Amendment No. **ONE**

Re: Invitation to Bid Number: **50-52100-24-06149**

Title: **Madrid Water Tank Project**

### **Question and Answer**

# Madrid Water Tank Project

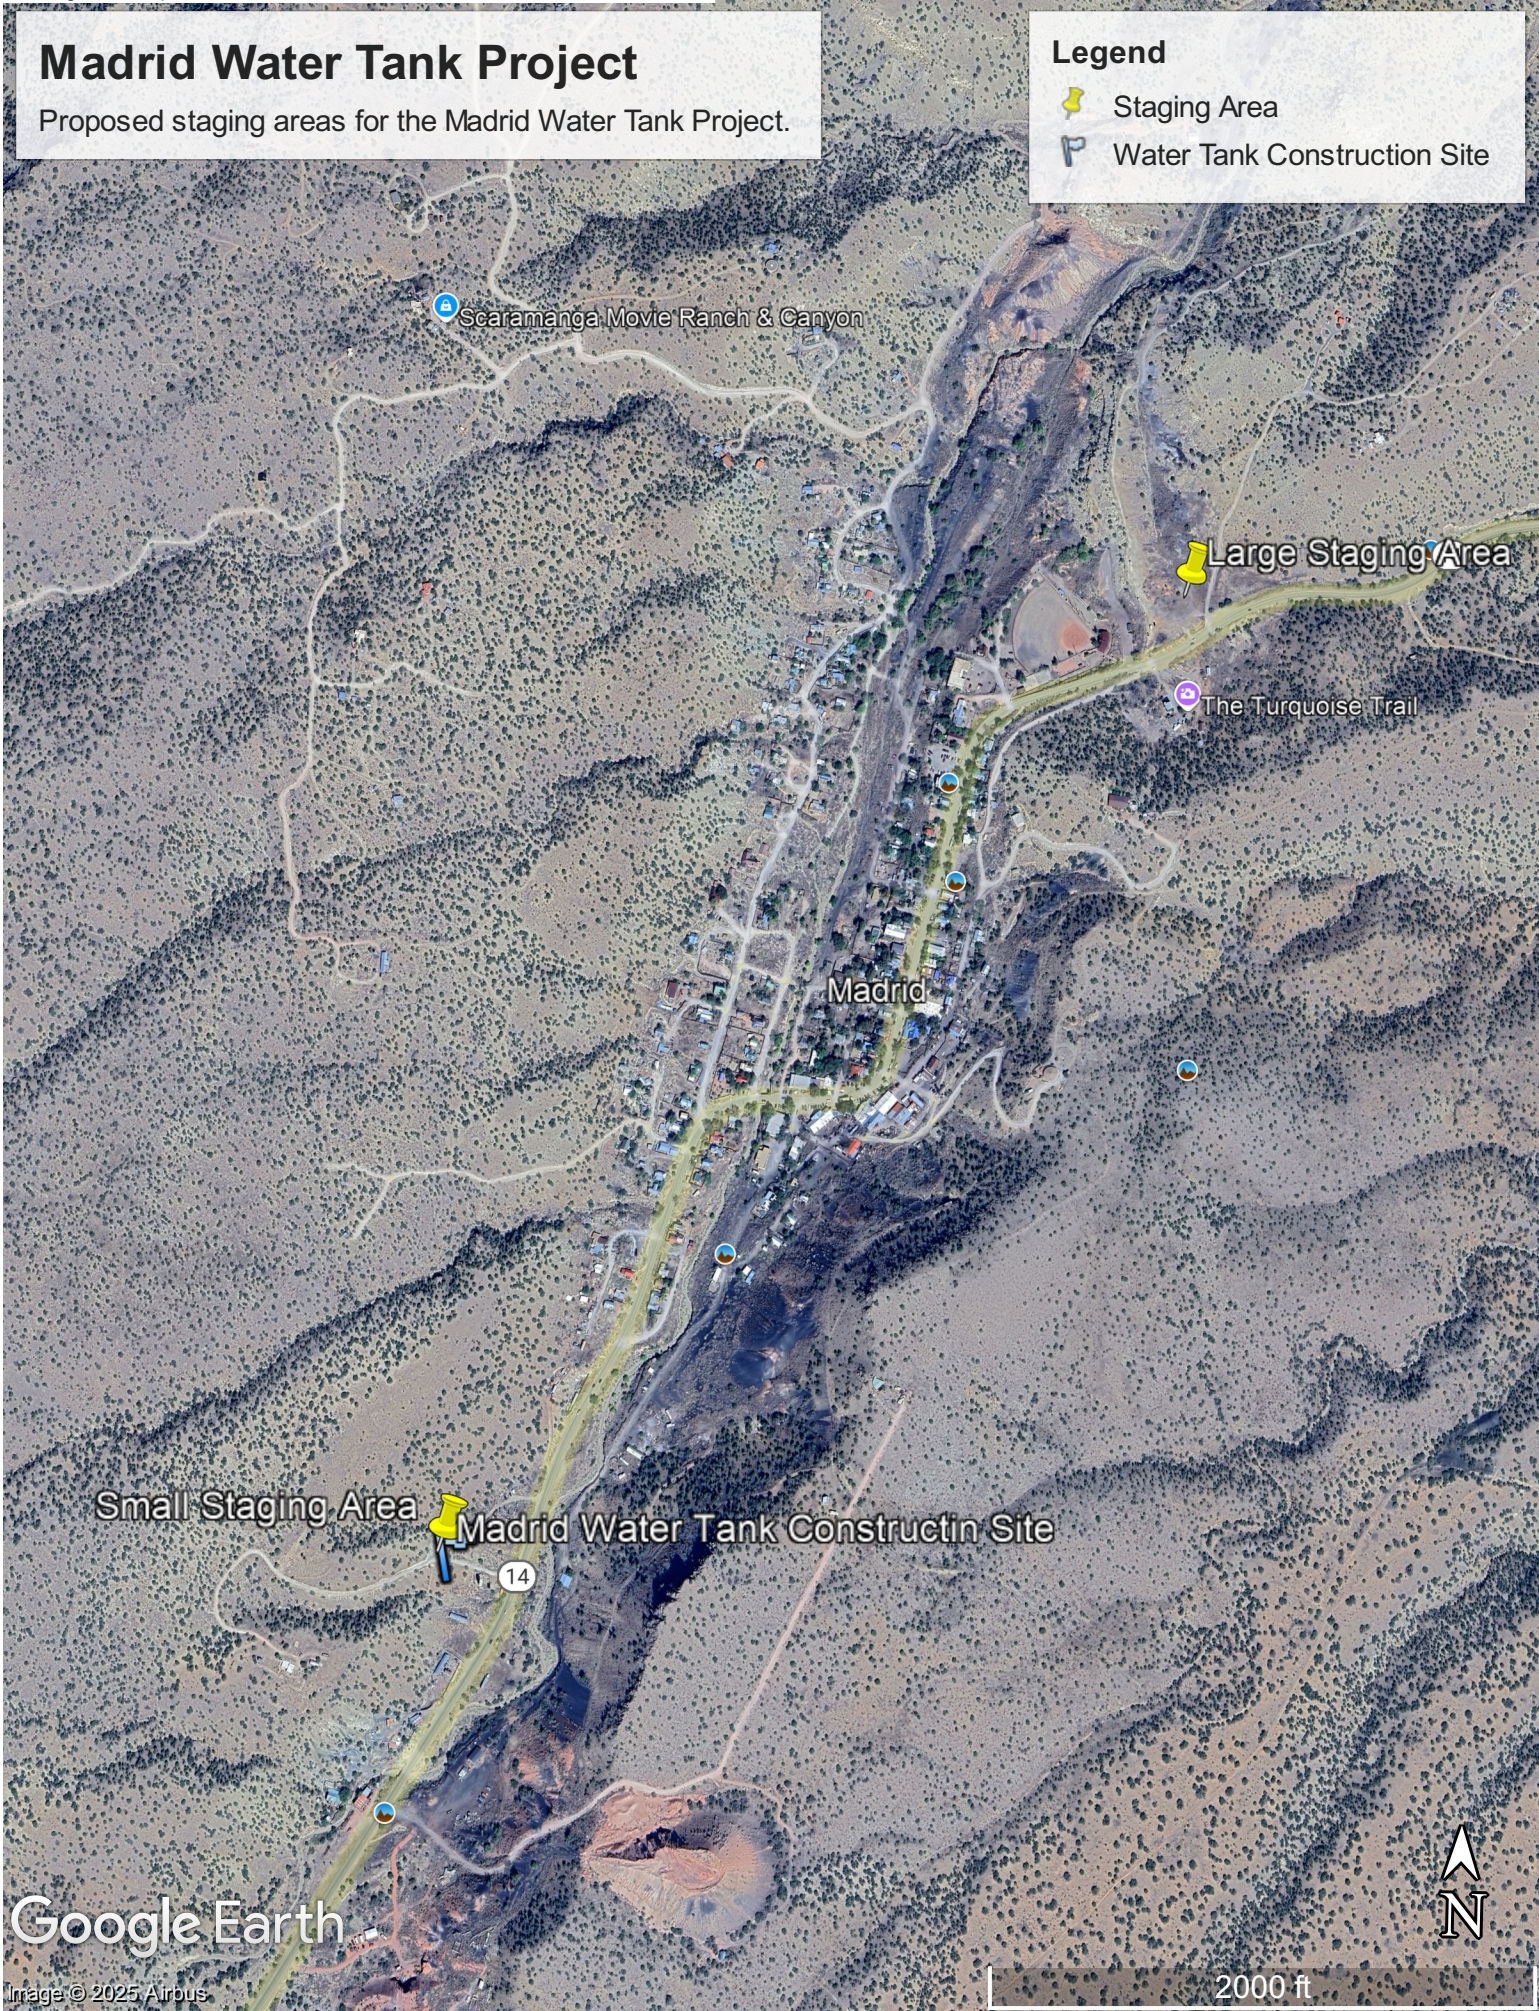
**33) Can AML identify available areas for equipment staging/soil stockpiling?** Yes, the following areas can be utilized for staging equipment/soil stockpiling. Please see the attached map.

- a. Small area located above the water tank for some equipment staging:  
35.400724, -106.157931
- b. Large soil/equipment staging located east of the Madrid Ball Park: 35.411024, -106.1485679

### BORING DETAIL

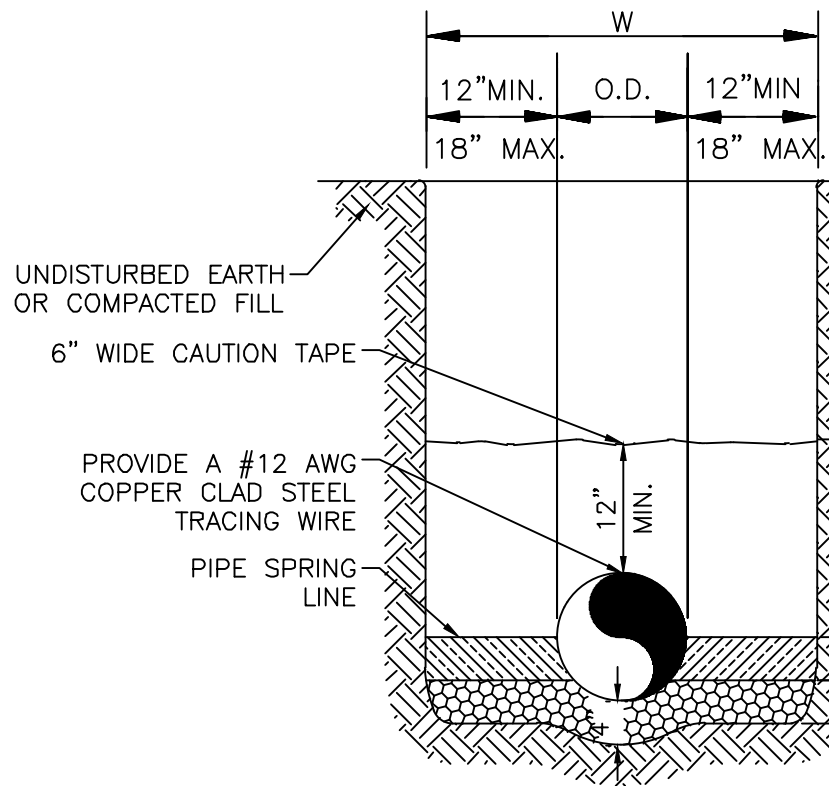
- 20) On Sheet 7 of the plans, the Boring Detail shows bedding above the casing pipe. Since this casing will be installed without digging, please explain the intent of this detail.** The hatch showing bedding above the casing pipe on Sheet 7 was incorrect and was removed from the detail.

PROJECT NO. EMNRD-MMD-2025-01 ZONE MAP NO. - SHEET 9 OF 16

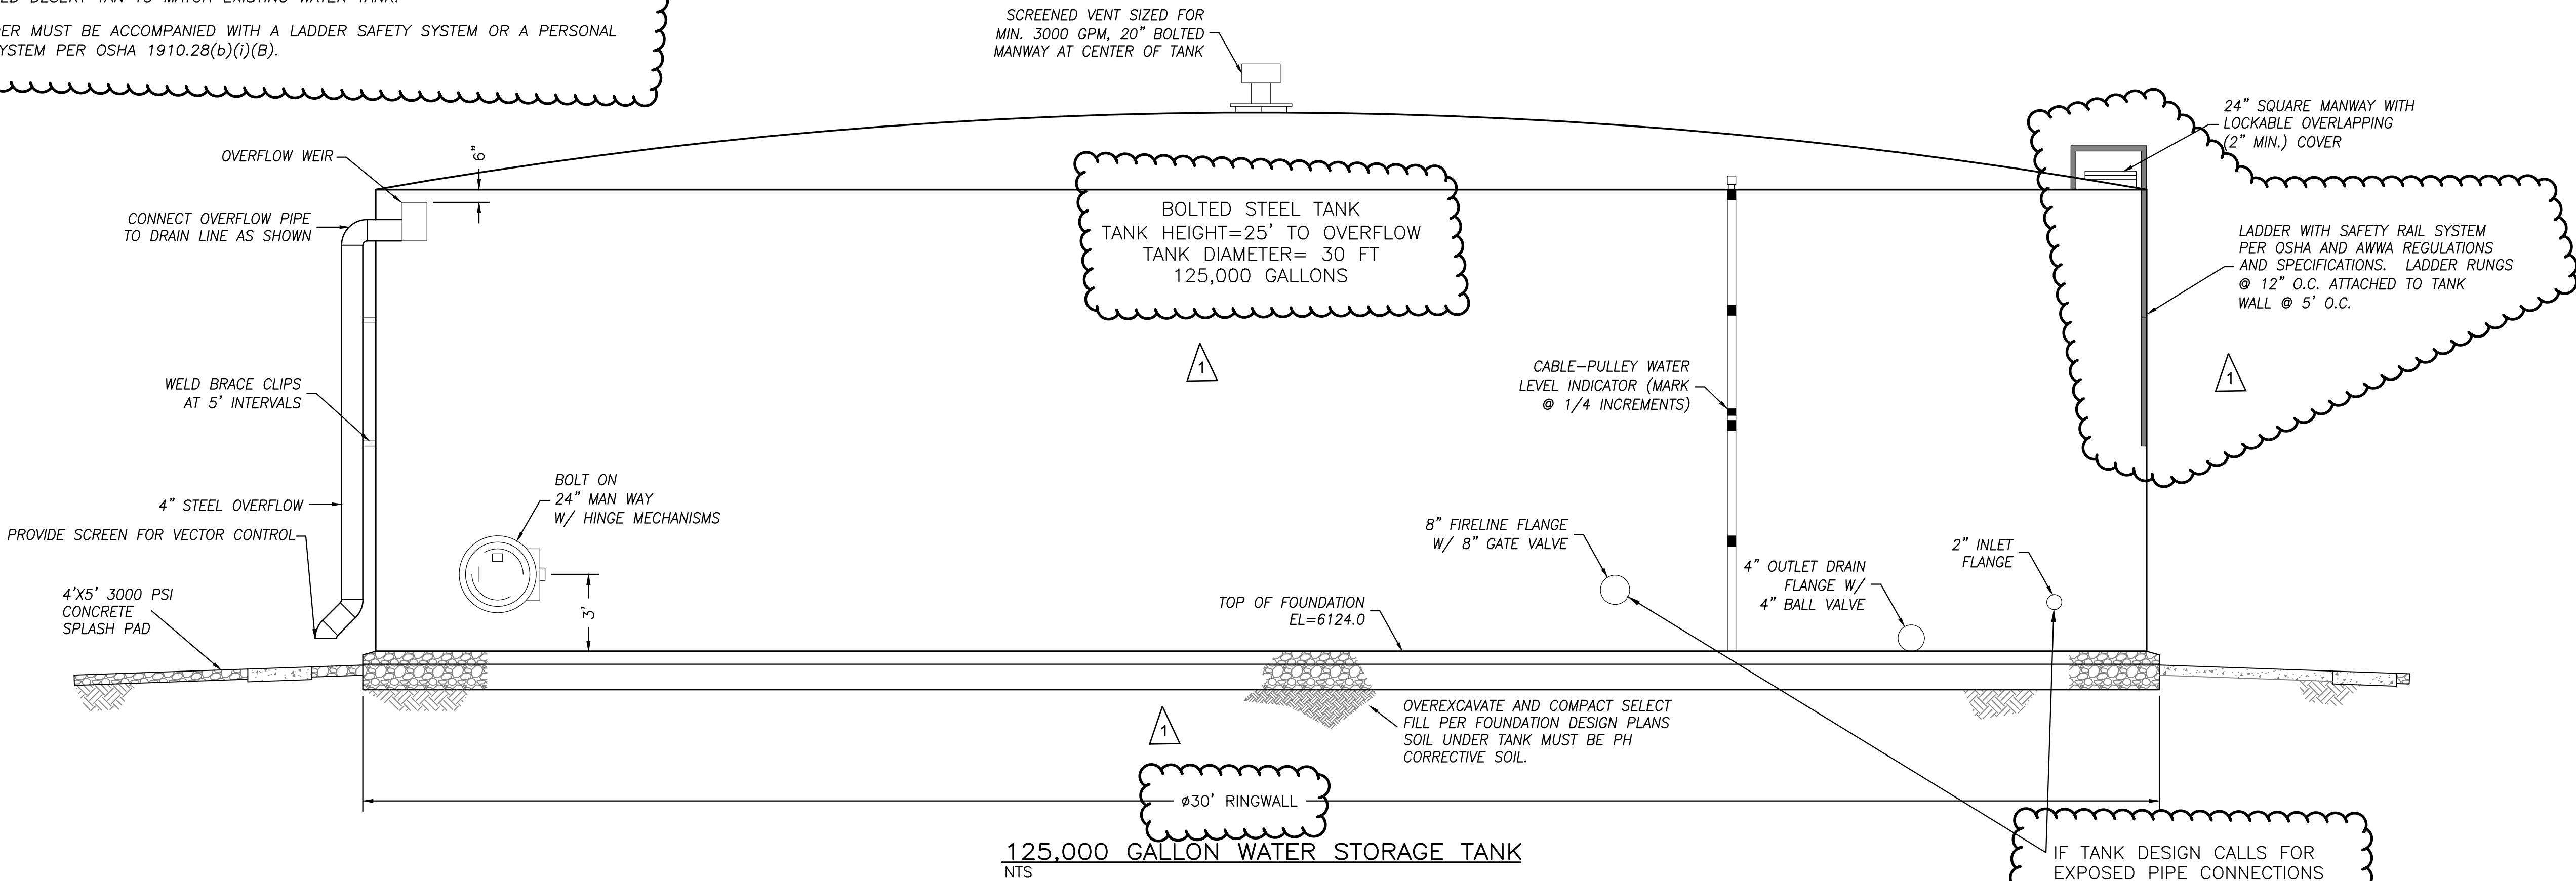
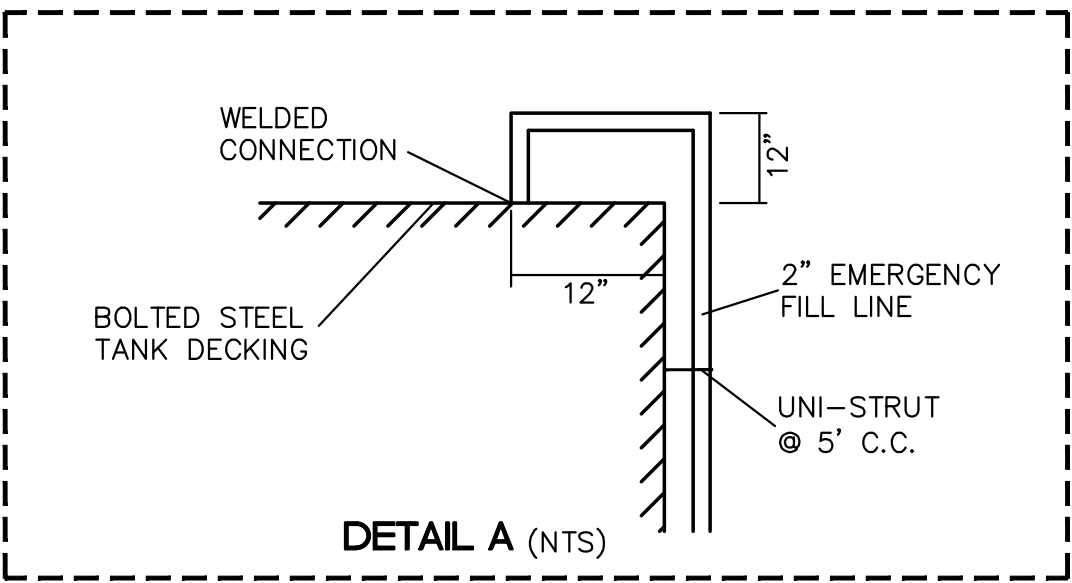
- 24) On sheet 9 there are three exposed pipes that need to be protected against freezing, please provide details for this work.** This may or may not be needed depending on the tank used for the project. Exposed pipes be blanketed and/or be wrapped in heat tape until pipe is buried to local frost level. Assume 10' of freeze protection for each pipe run. This will ultimately be coordinated with the local utility.

SHEET 13 OF 16

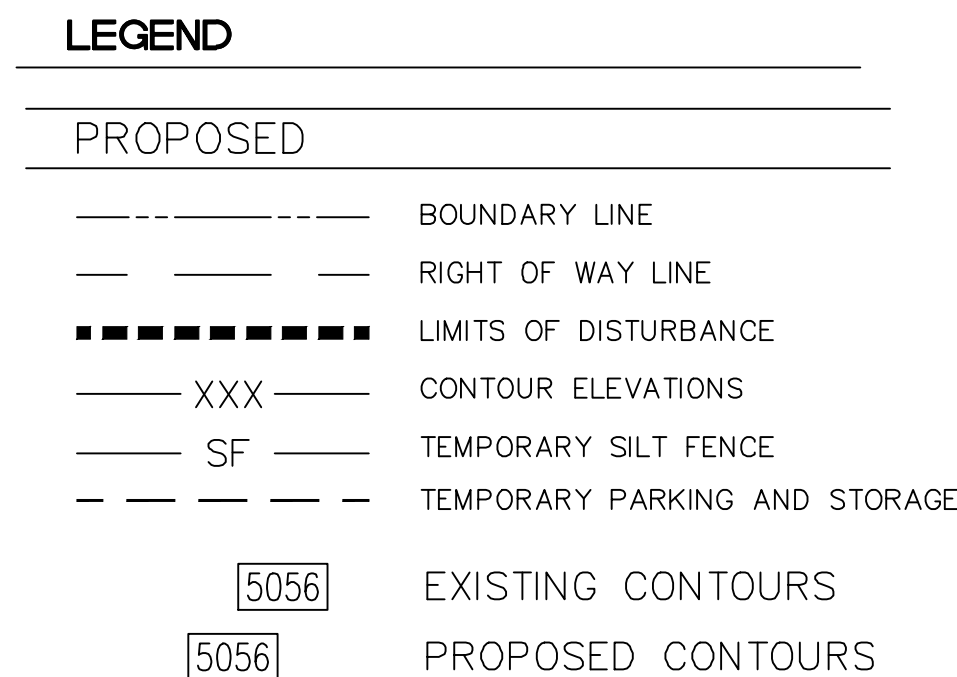
- 22) Note 1 on sheet 13 of the plans, requires that the sloped embankment be built with 3" to 4" fractured rock and Mirafi fabric. Please clarify the vertical distance between the layers of the Mirafi fabric.** This note is a reference to slope stabilization Use Mirafi 180N or equivalent and anchor fabric at the top and bottom of the slope by burying a 2' fabric overlap in a minimum 12" depth trench. Install anchor pins (3/16" diameter x 18" with washer cap) or (11 gauge 6" x6" staples) 12" o.c. in fabric overlap and bury overlap in trench. Install staples or pins 3' o.c.e.w in field of fabric and every 6" along laps and edges. Provide 6" fabric overlap on all seams. Install 8" of 3-4" fractured rock directly on fabric.
